CITY OF ALBUQUERQUE

Re: Duplex for Ahmet Tiryaki
12016 Copper Ave. NE
Traffic Circulation Layout
Architect's Stamp: 9/4/2022 (K22D065)

The revised TCL received 9/5/2022 with comments addressed is approved for building permit by Transportation.

RE: **DUPLEX PROJECT FOR TIRYAKI**, 12,016 COPPER AVE NE, ALBUQUERQUE, NEW MEXICO,
TRAFFIC CIRCULATION LAYOUT (K22-D065)- ARCHITECT'S STAMP DATED 7/7/2022 - RESPONSE
TO TRAFFIC CIRCULATION COMMENTS DATED 8/10/22.

DRAWING TITLE: **TRAFFIC CIRCULATION LAYOUT**

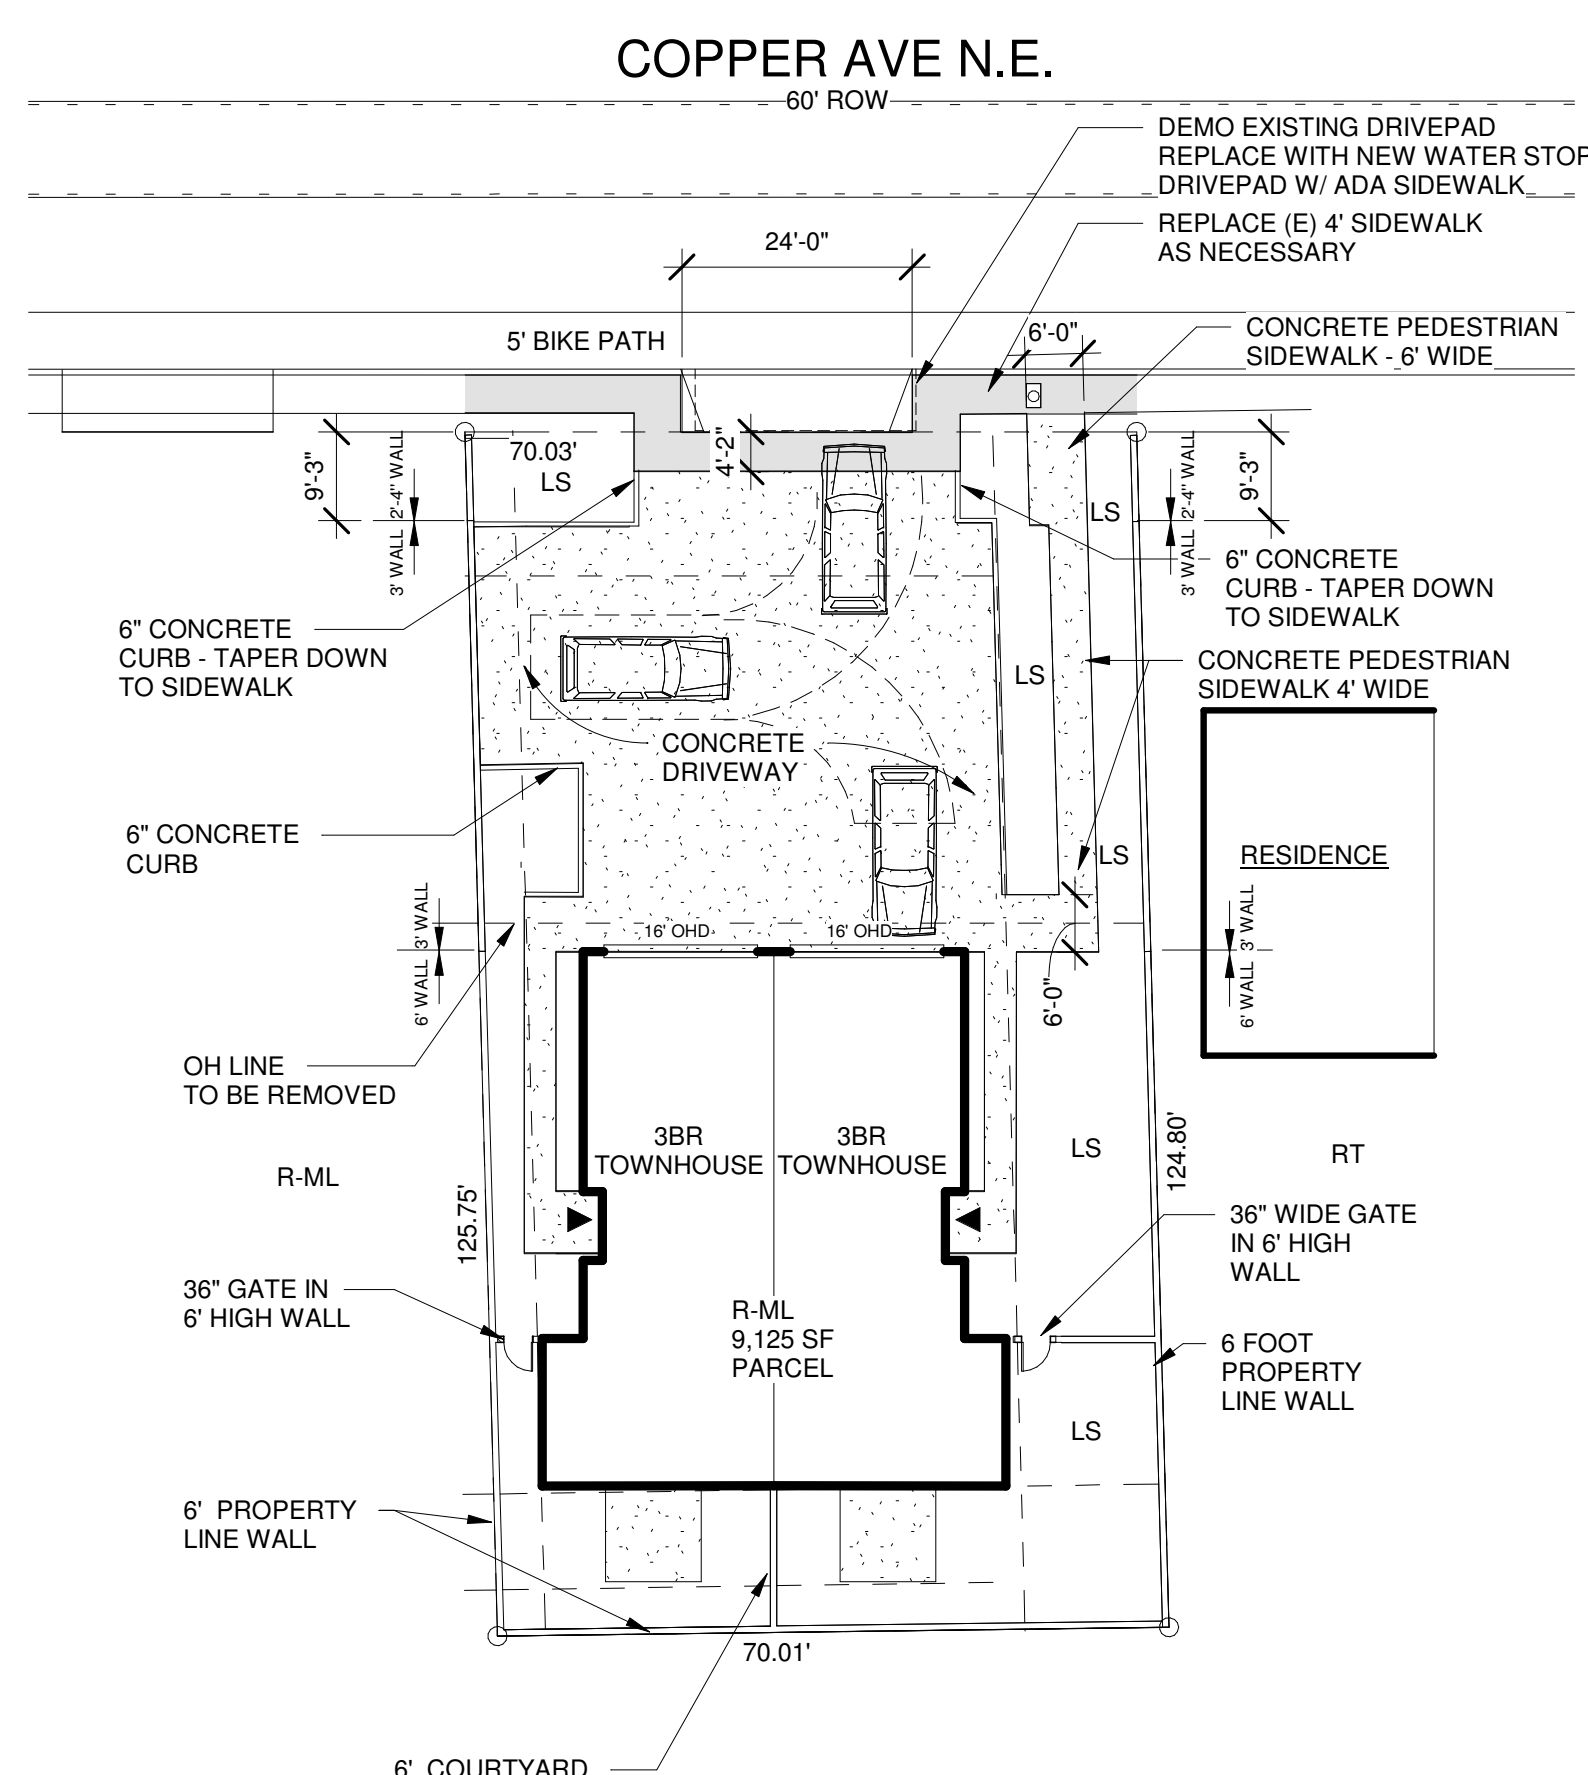
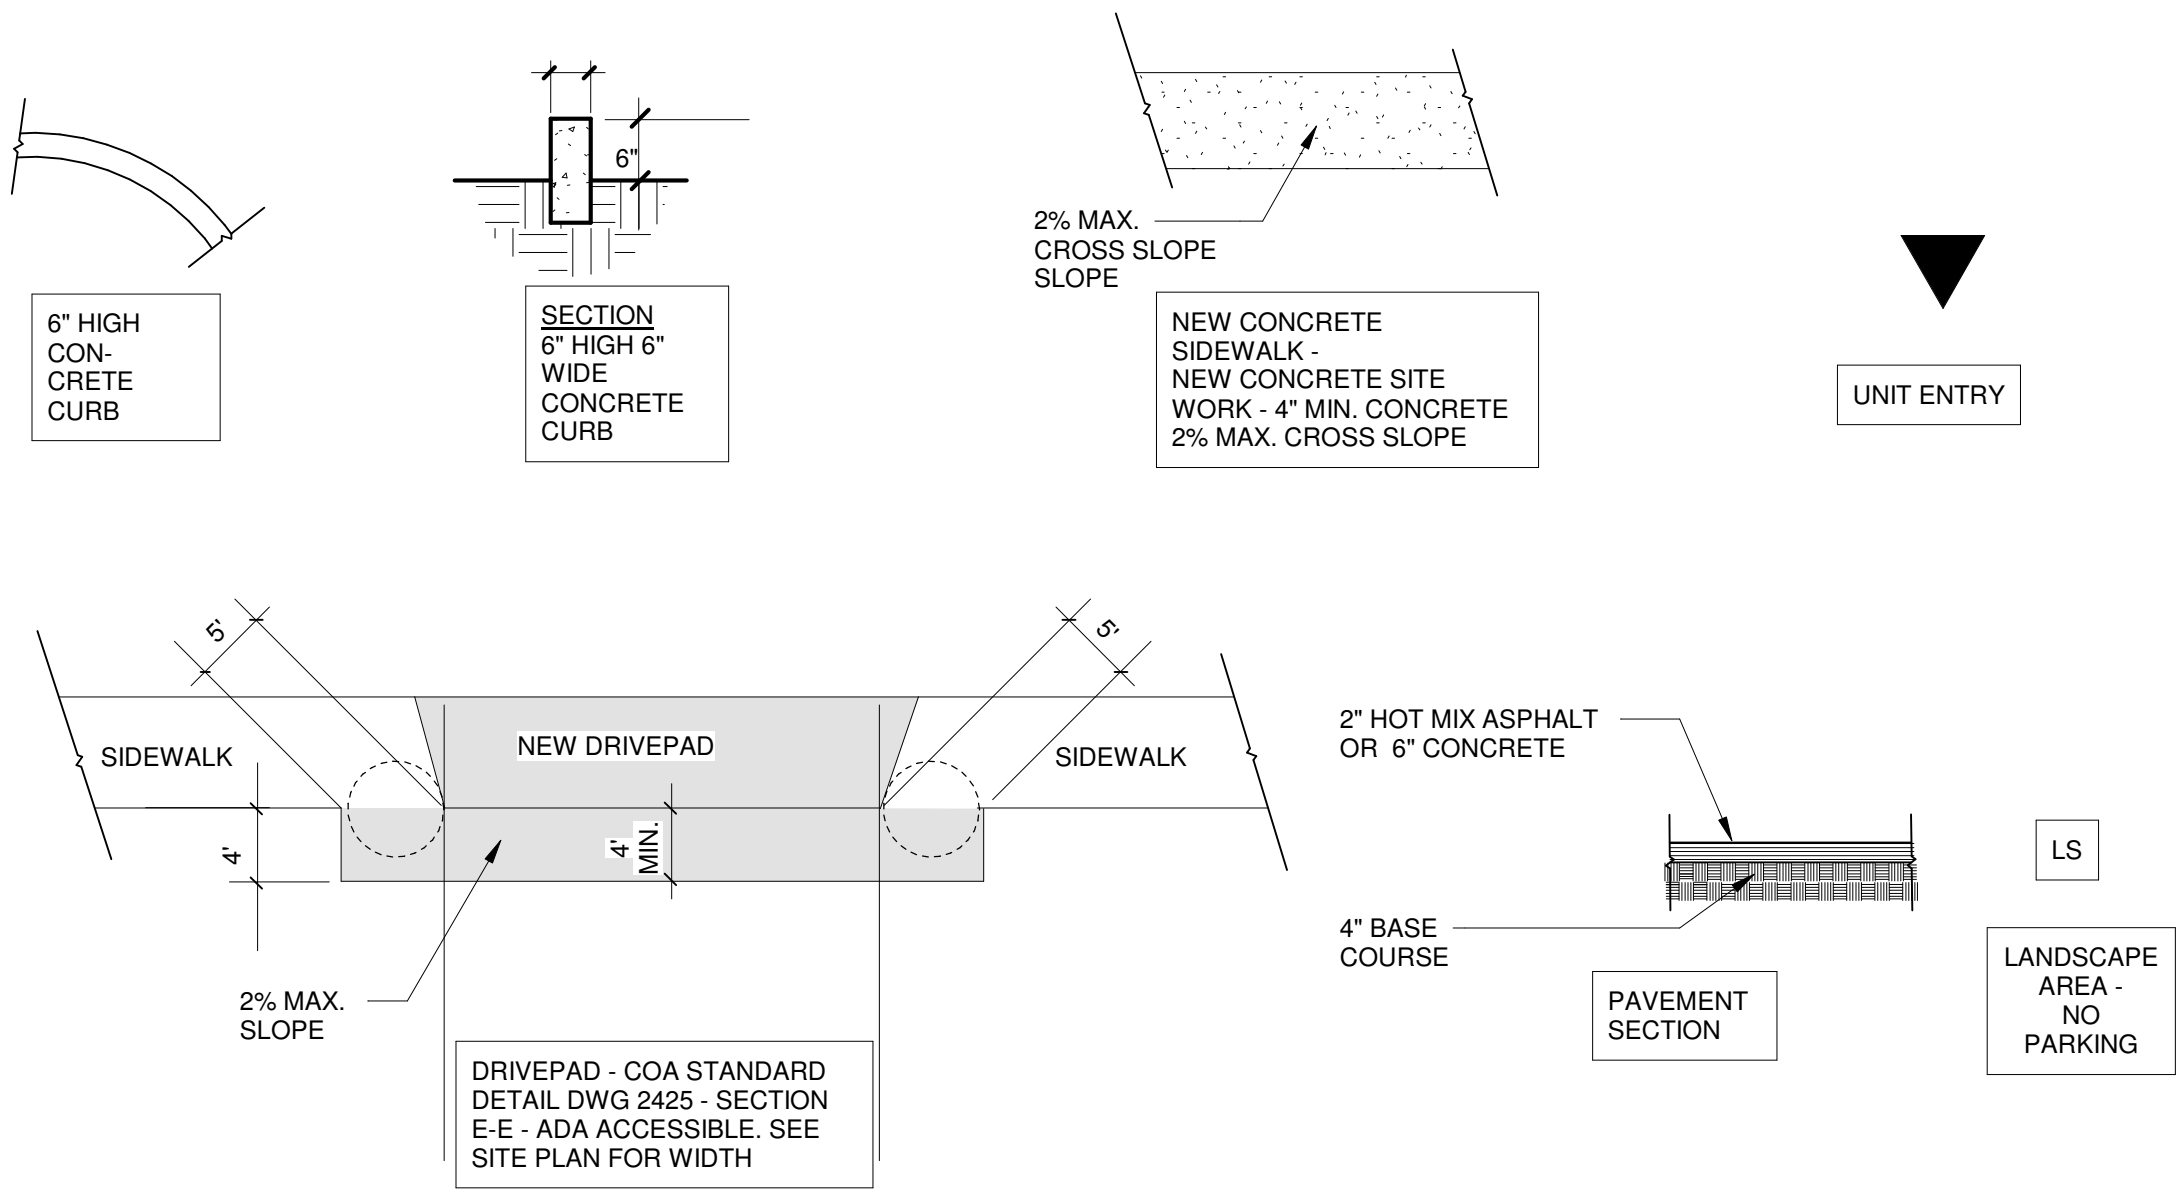
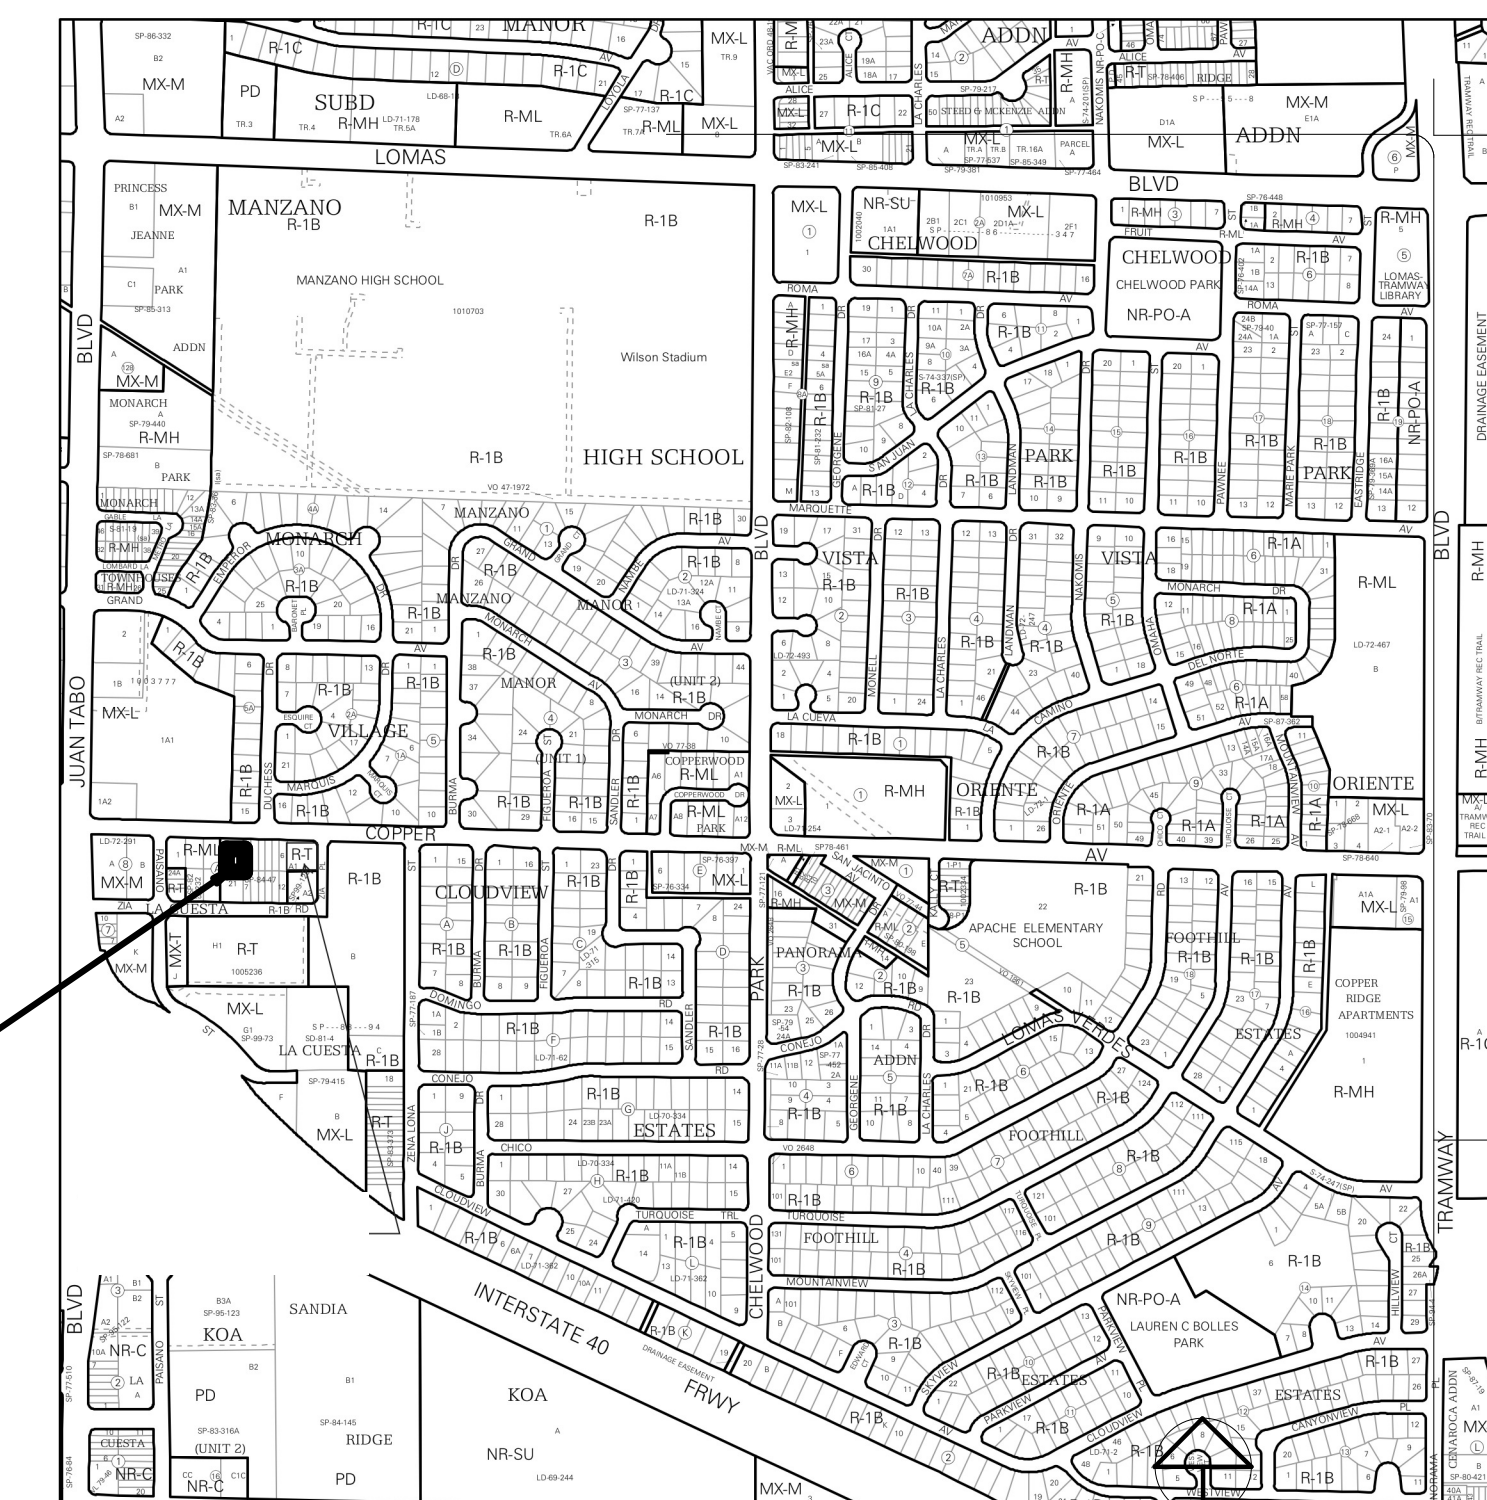
1. PER DISCUSSION WITH ZONING, LOW DENSITY DEVELOPMENT DOES NOT REQUIRE MOTORCYCLE OR BICYCLE PARKING. PARKING SPACE CALCULATION IS ACCEPTABLE.
2. PROPOSED DRIVEPAD 2425 IS APPROVED AS SUBMITTED. SEE APPROVAL CORRESPONDENCE ATTACHED.
3. NOT APPLICABLE
4. NOT APPLICABLE
5. NOT APPLICABLE
6. EXISTING 4' SIDEWALK SHALL BE REPLACED WHERE APPLICABLE
7. SEE ATTACHED REFUSE 1 APPROVAL
8. LOW DENSITY DEVELOPMENT DOES NOT REQUIRE FIRE 1 SUBMITTAL PROCEDURE
9. PROPERTY LINE WALL IN STOPPING DISTANCE LINE CHANGED TO 36" ABOVE GUTTER FLOW LINE = 2'-4" HIGH.
11' X 11' CLEAR SIGHT TRIANGLE HAS BEEN REMOVED

**CONDITION OF C.O. (FINAL) APPROVAL:
SIDEWALK EASEMENT FOR 24'
DRIVEPAD SHALL BE APPROVED,
ACCEPTED AND IN PLACE. (NSF)**
